Fremont K-8 School

2nd Submittal S. Supplement

CITY OF LAS VEGAS INTER-OFFICE MEMORANDUM		DATE: June 20, 2019
TO: Land Development Services Department of Building & Safety		FROM: Albert Sung, P.E. Flood Control Project Engineer Department of Public Works
SUBJECT:	Drainage Study for: Fremont K-8 School	
Cross Streets:	SWQ of Maryland Pkwy. & St. Louis Avenue	COPIES TO: Lochsa Engineering
File Number:	F:\Depot\DSMemos\DS5124B.doc	Clark County School District
Parcel Number:	162-03-801-005	Bart Anderson, P.E., DevCo
Zoning Action:	SDR-76201 & VAR-76200	
FEMA Flood Zone	YES	NO X
Proposed Storm Drain	YES	NO X

**Addendum to
Technical Drainage Study
For
Fremont K-8 School
(MPID#1623)**

Response to Comment #8

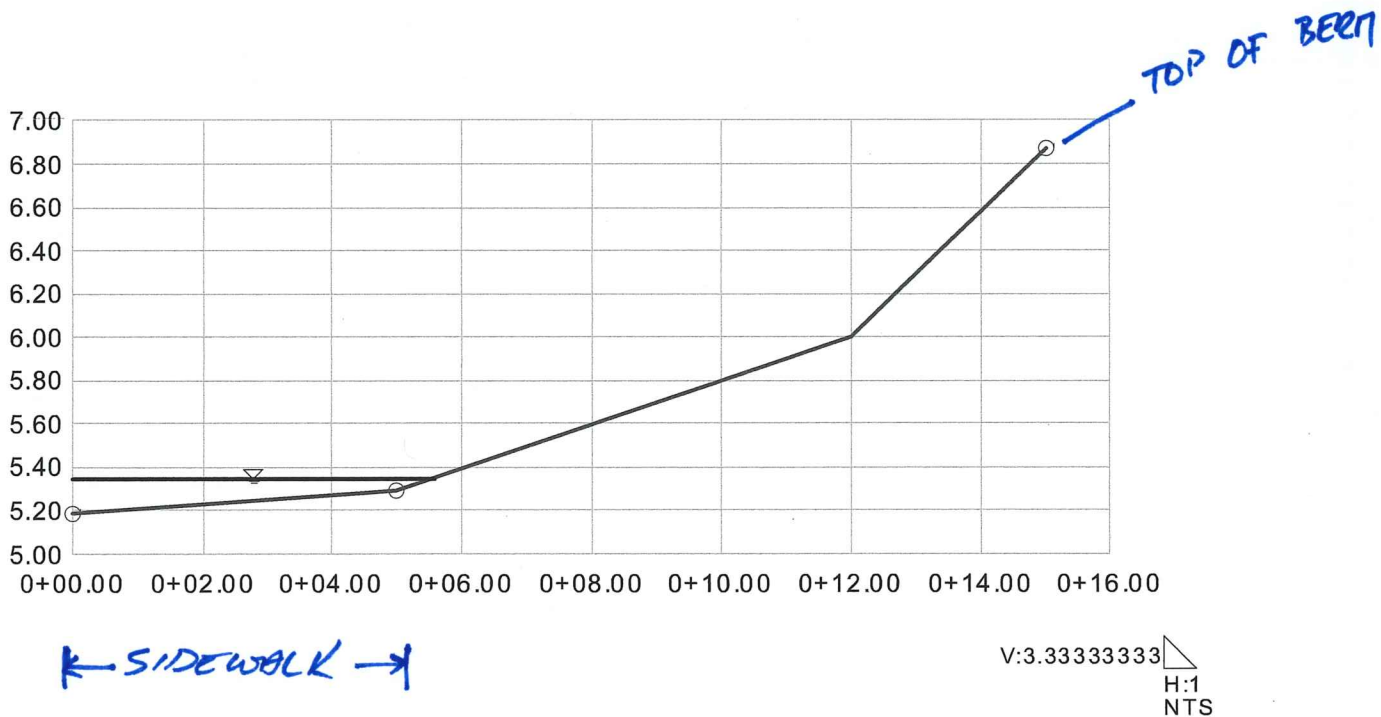
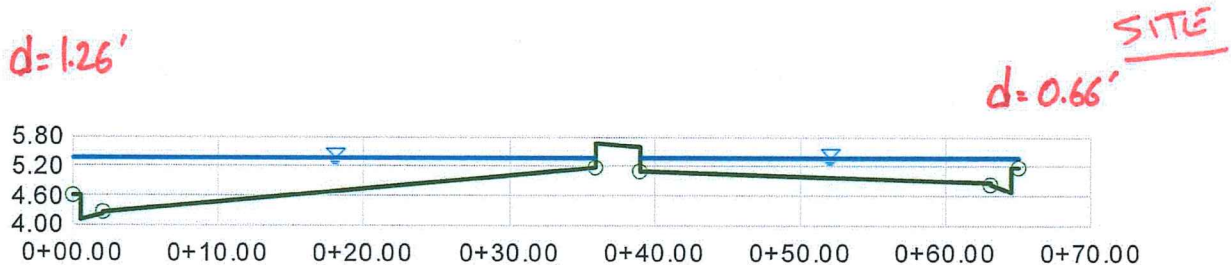
8. A berm is provided at the back of sidewalk in *St. Louis Avenue* for onsite flood protection. The 100-year flow velocity in *St. Louis* is 6.5 ft/s which is erosive. Provide erosion protection measures on the side of the berm facing the street. Revise the plans, construction callout and *Detail Sections A/C6.02* and *B/C6.02* accordingly.

Response 8: Noted. The flow depth along *St. Louis avenue* is 0.66ft with a velocity of 6.51ft/sec. However, only 0.06ft of flow would be against the berm from back of side walk. Per our email conversation with Albert Sung PE of City of Las Vegas, the hydraulic section performed with the depth of 0.06ft indicate a velocity of 2.30ft/sec which is below 5ft/sec. The velocity is considered non erosive since it is below 5ft/sec. Please refer to the hydraulic section, detail section *B/C6.02* from the civil plans and the copy of the email enclosed within this addendum.

SHEET NO: **DR1**
SHEET 1 OF 1

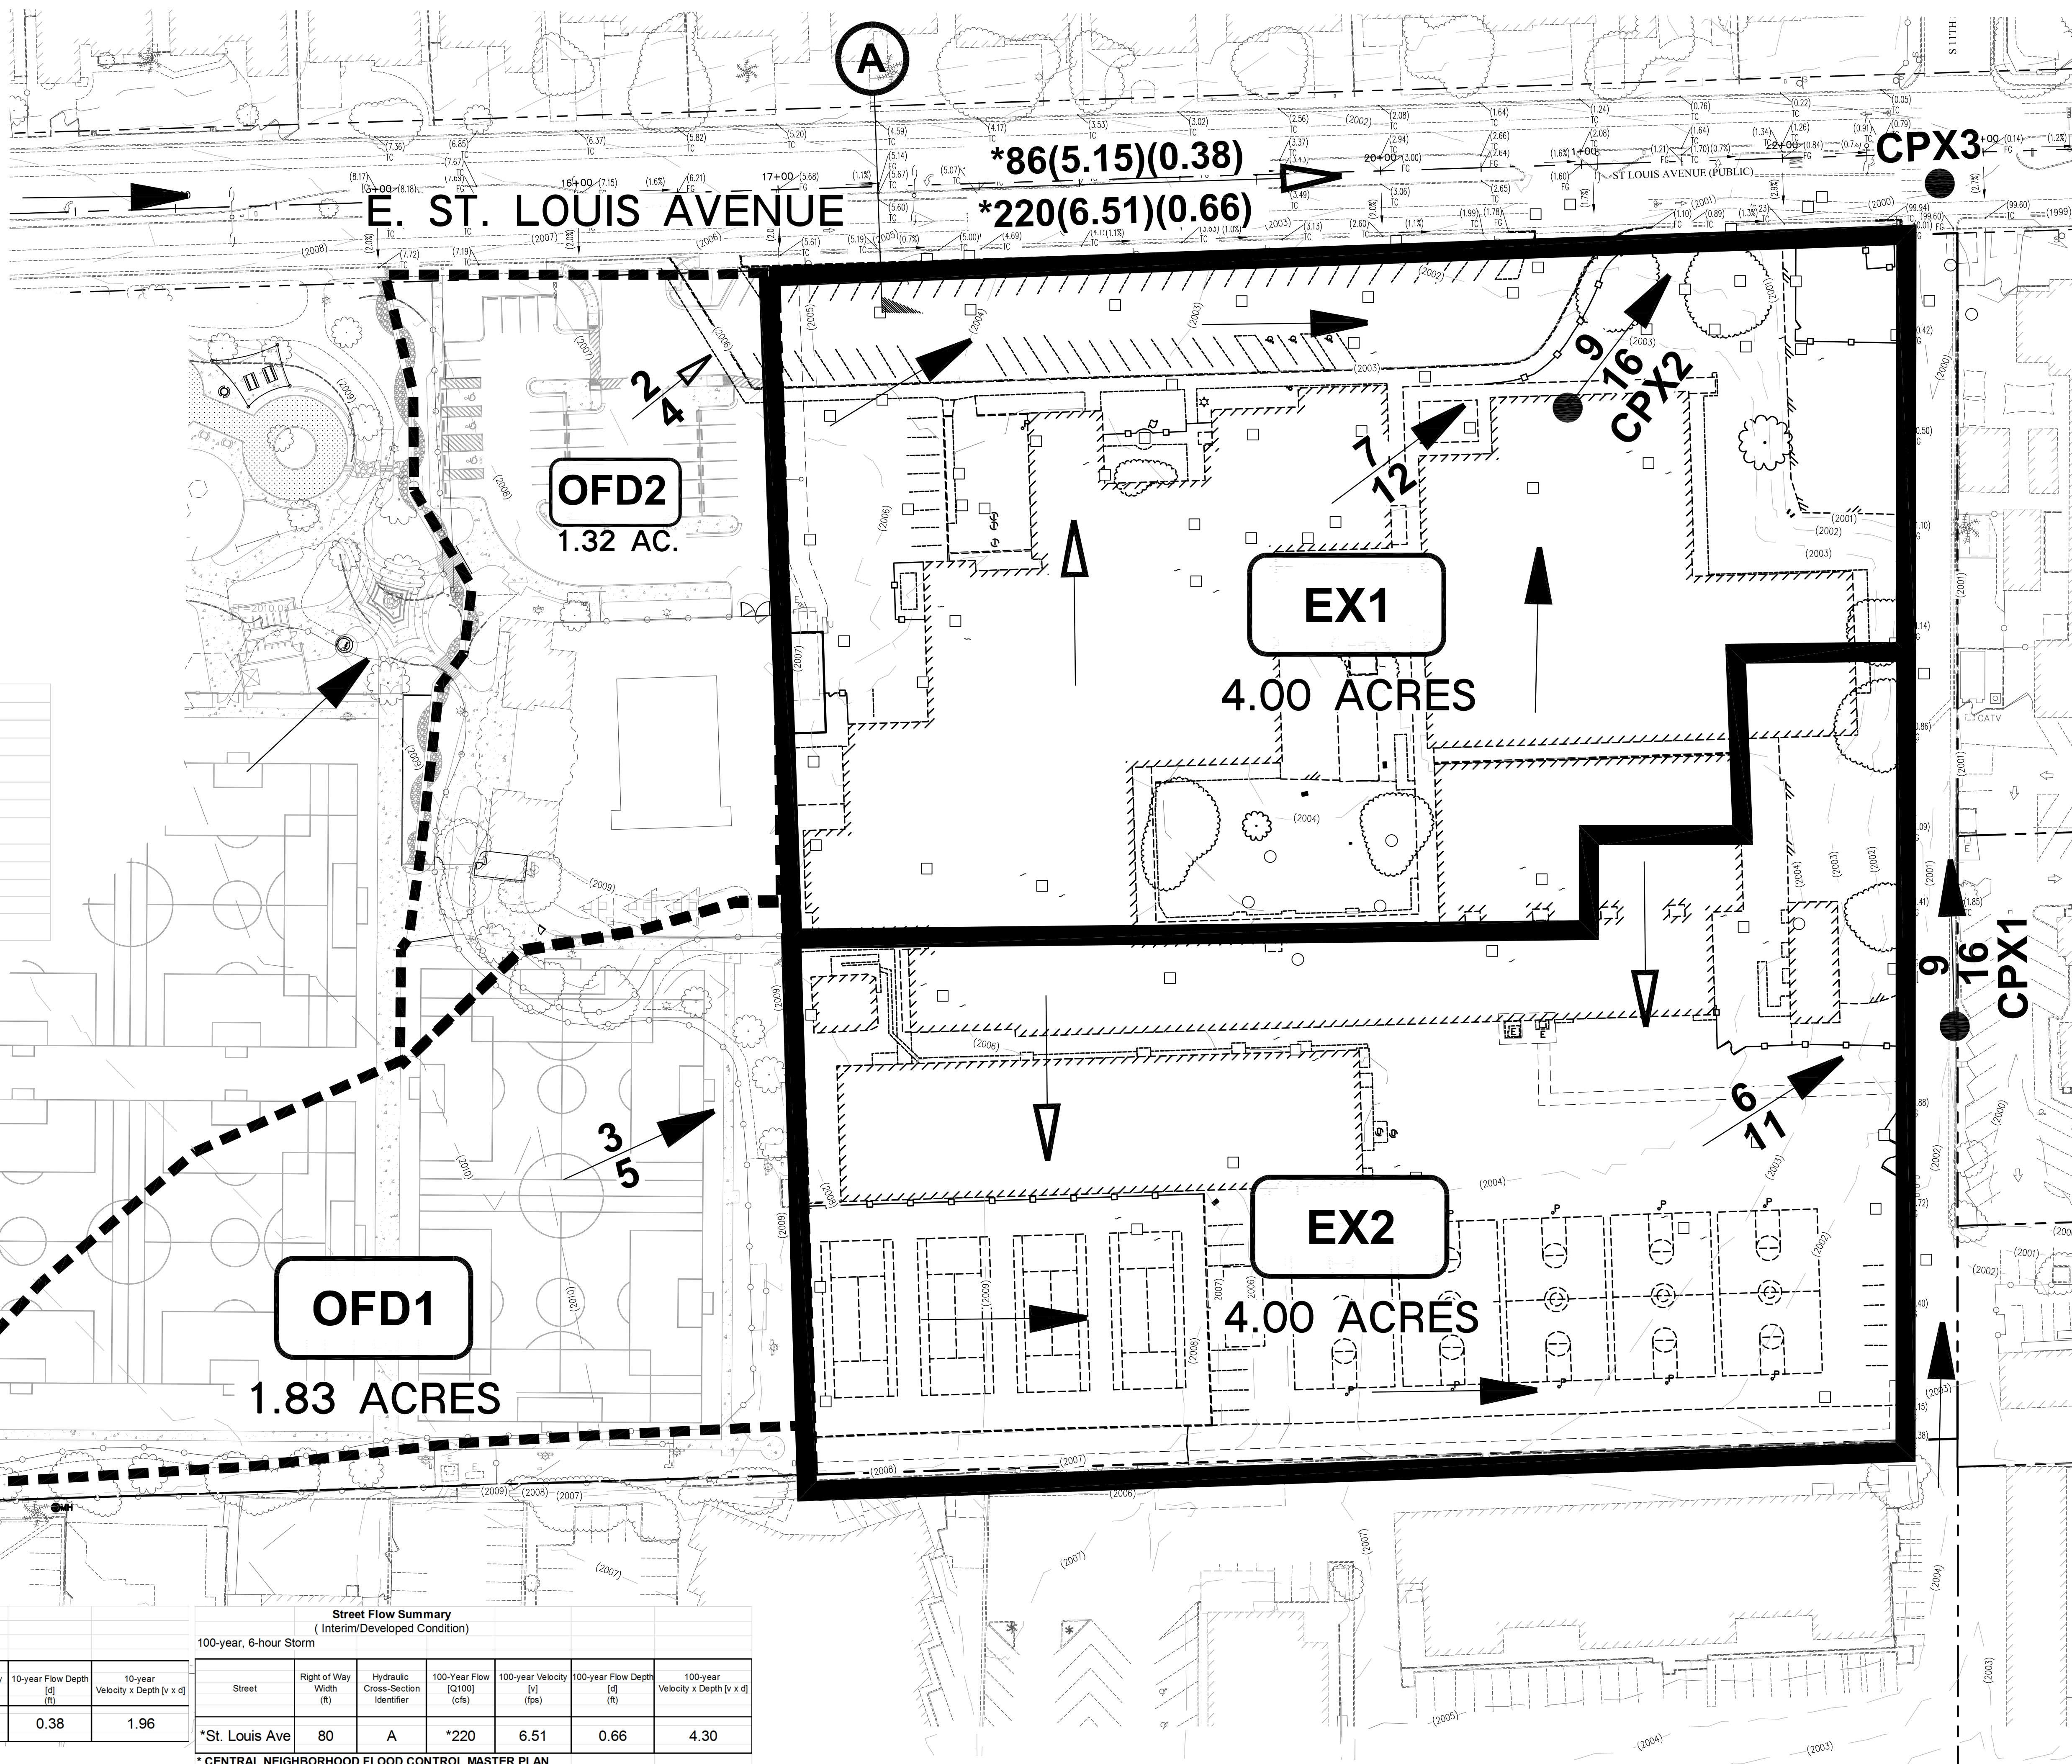
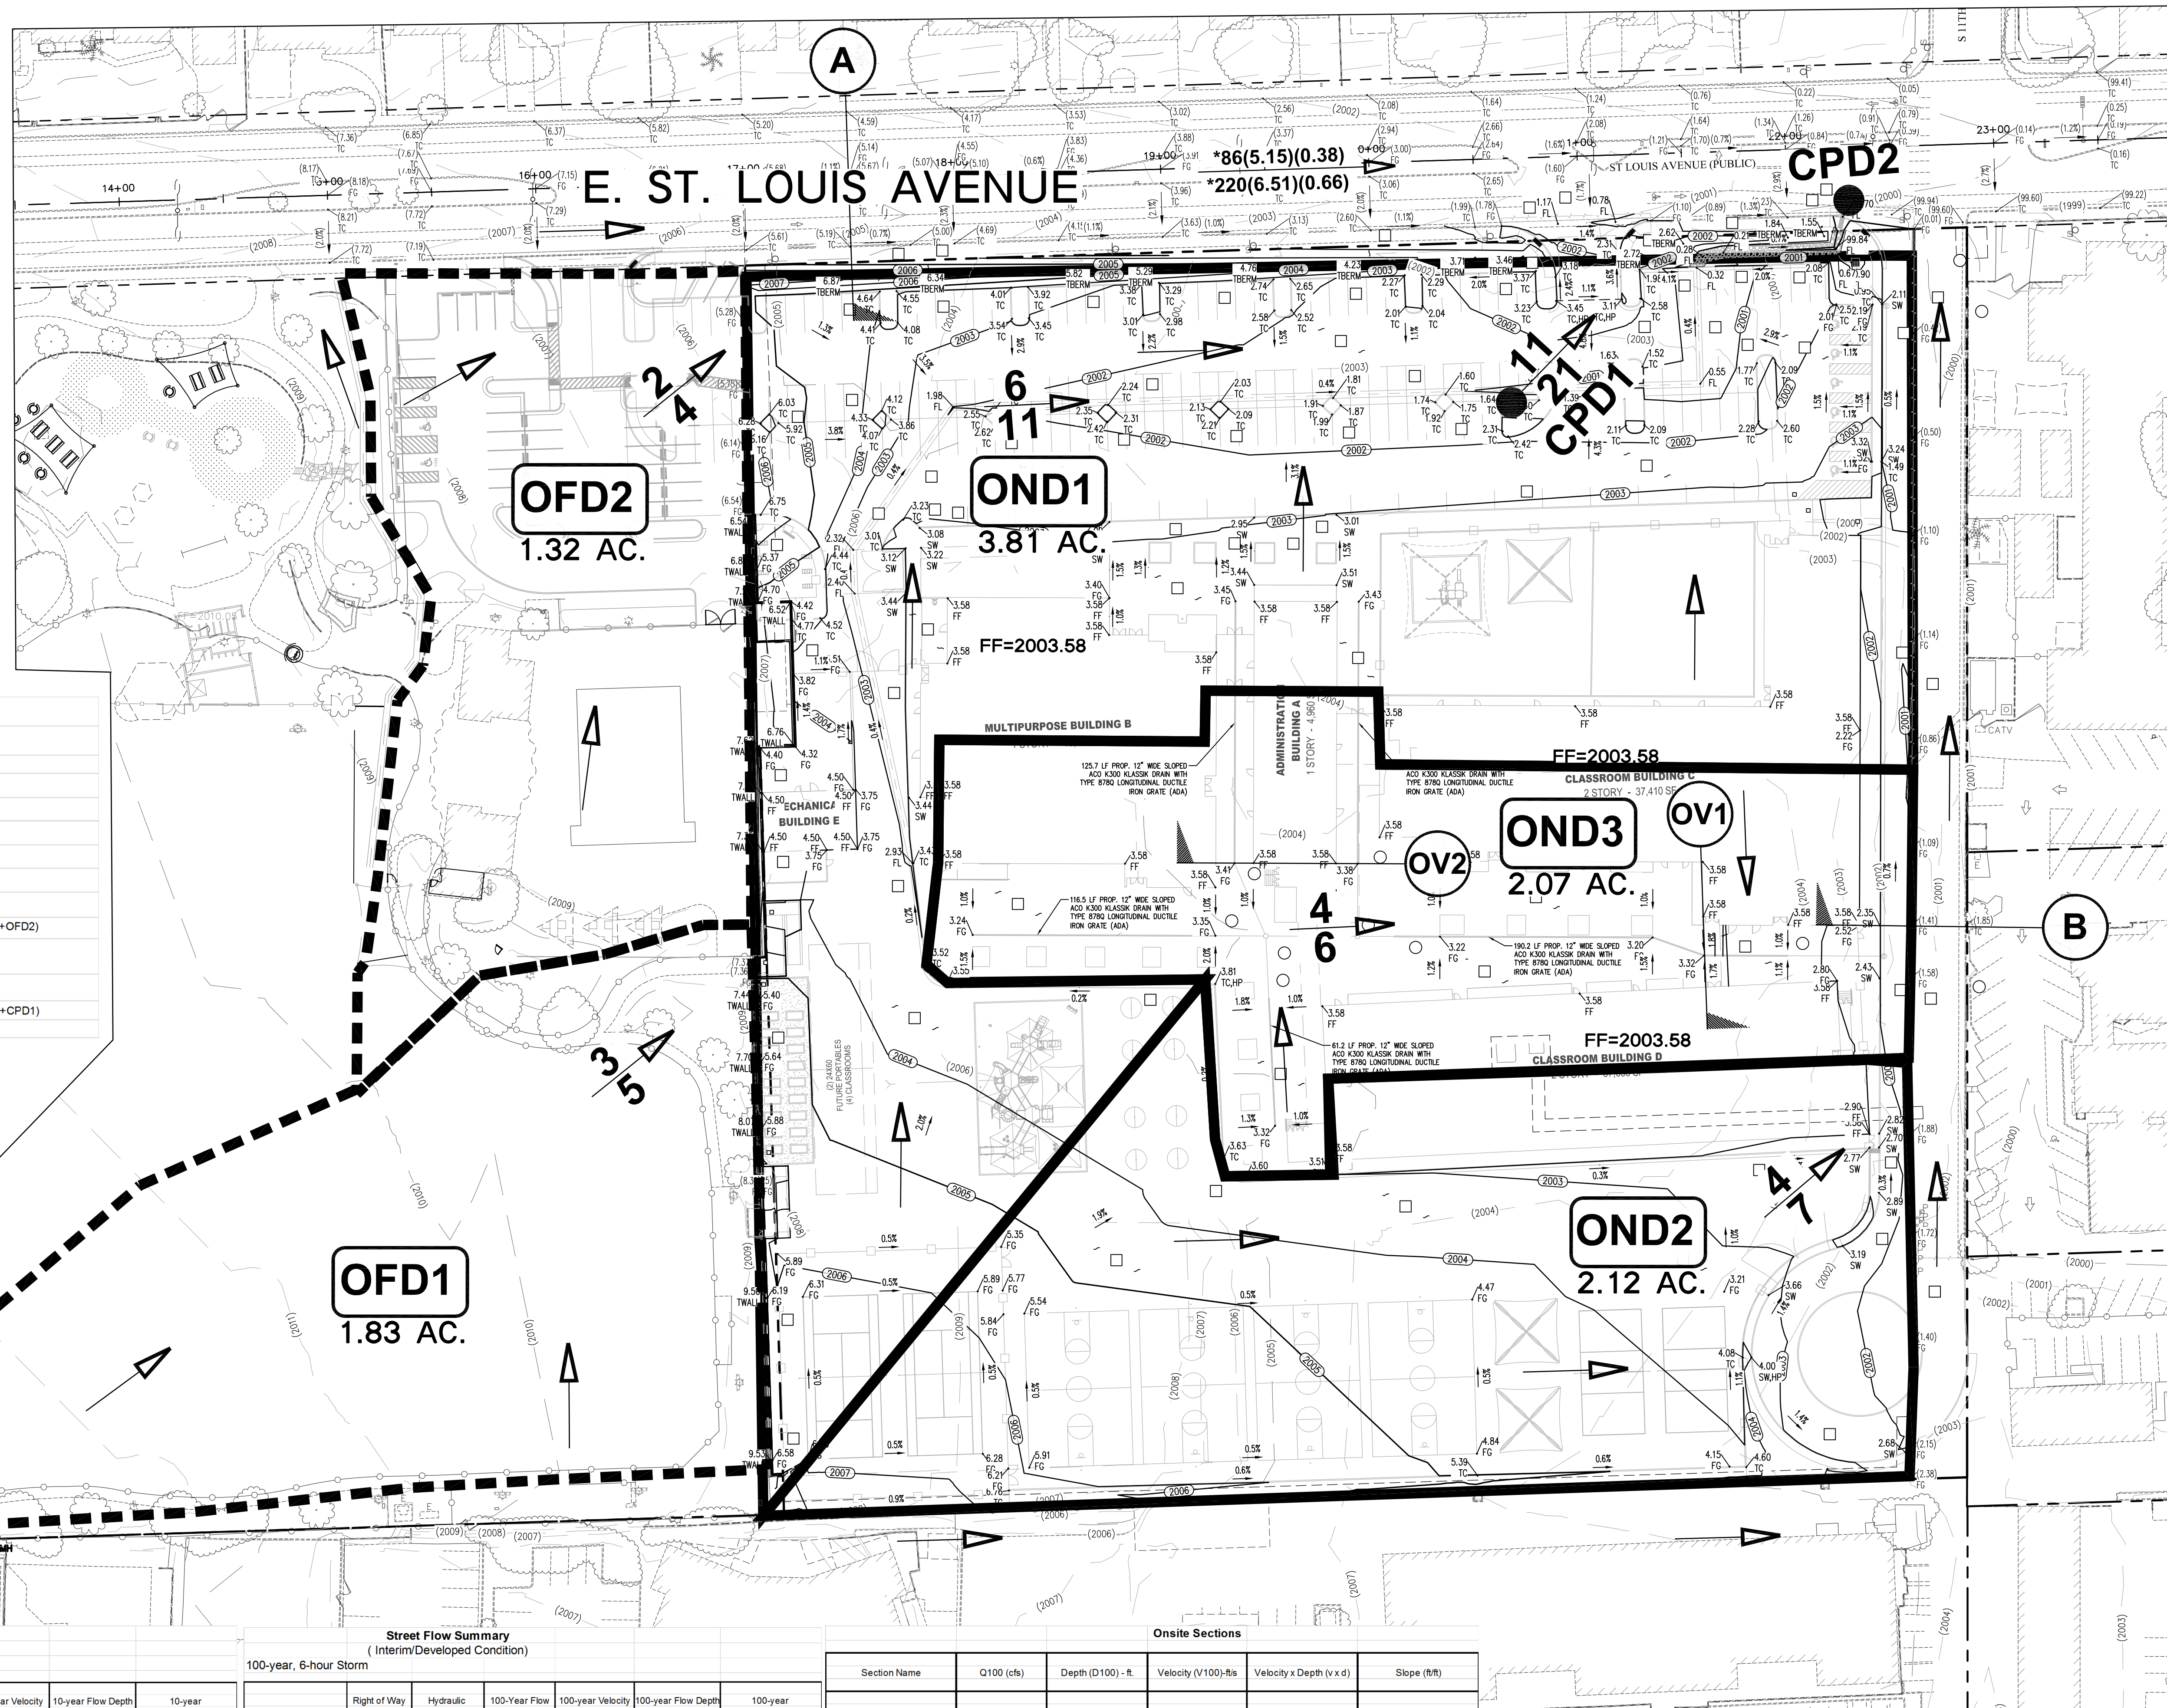
4. *Sheet DR1 (Existing Condition Basin Map):* It appears that concentration point CPX2 is wrongly located at the east end of the parking lot. Should it be located exactly at the northeast corner of the school site? Review and revise accordingly.

6. Per the *Baker Park Improvement Plans*, it appears that the Park is basically drain through the subject school site which does not agree with the depiction of only *Basin OFD1* is impacting the school site as shown in the subject DR1 and DR2 Basin Maps.

Response 4: Noted. The combination point 'CPX2' is now replaced by 'CPX3' (17/32cfs) which represent to total storm generated runoff for the subject site. Since the addition of offsite basin 'OFD2', the HEC-1 analysis for the existing condition has been revised as well. Offsite basin 'OFD2' delineation is based on comment #6 below. Therefore, combination point 'CPX3' has been relocated to the northeast corner of the subject site. Please refer to the revised figure DR1, Existing Condition Basin Map.

Response 6: Noted. Upon reviewing the Baker Park approved civil plans, we have delineated offsite basin 'OFD2' (2/4cfs – 1.32acres). Offsite basin 'OFD2' is comprised of mostly surface parking and impacts the subject site from the westerly direction and the storm generated runoff shall drain through the subject site.

Per the revised HEC-1 analysis for the Existing Condition, offsite basin 'OFD2' is combined with onsite basin 'EX1' at combination point 'CPX2' (9/16cfs) and combination point 'CPD1' (11/21cfs) for the Developed Condition, respectively. Please refer to the exhibits DR1 and DR, as well as the revised HEC-1 analysis for both Existing and Developed Conditions enclosed within this addendum, respectively.
